TECHNICAL BULLETIN

Custom Fit Radiators

Applies to: 91010, 91020, 91050, 91060-1, 91080, & 92010 Radiators.

Re: Automatic Transmission Cooler Fittings

.640" Deep 1/2"x20 IF Cooler Fitting
(91010, 91020, 91050, 91060,
91080, & 92010)

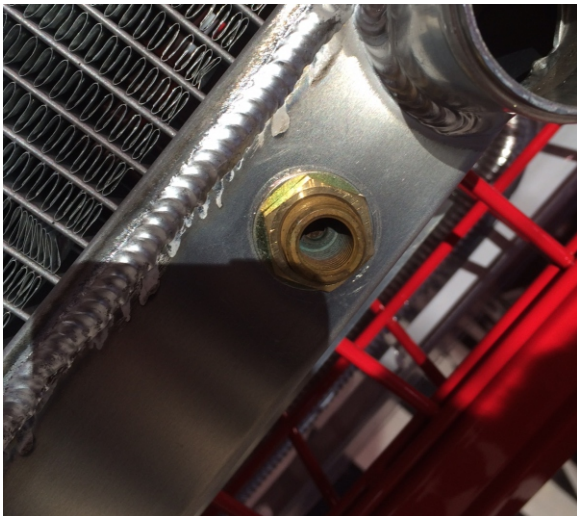
The factory installed coolers in the above noted radiators have an extra deep inverted flare fitting.

Only specific fittings will seat properly as standard fittings bottom out on the hex before seating on the flare.

Derale (#13024) and Hayden (#394) offer an extra long barbed fitting that will work. We have a specific fitting that will allow the use of a -6AN (9200506L). It is sold as a 2/pk.

Alternatively, the protruding threaded portion could be cut down (with a fine disc cut-off tool) to accommodate a standard fitting but we do not recommend it as damage to the cooler/radiator may result if not performed properly.
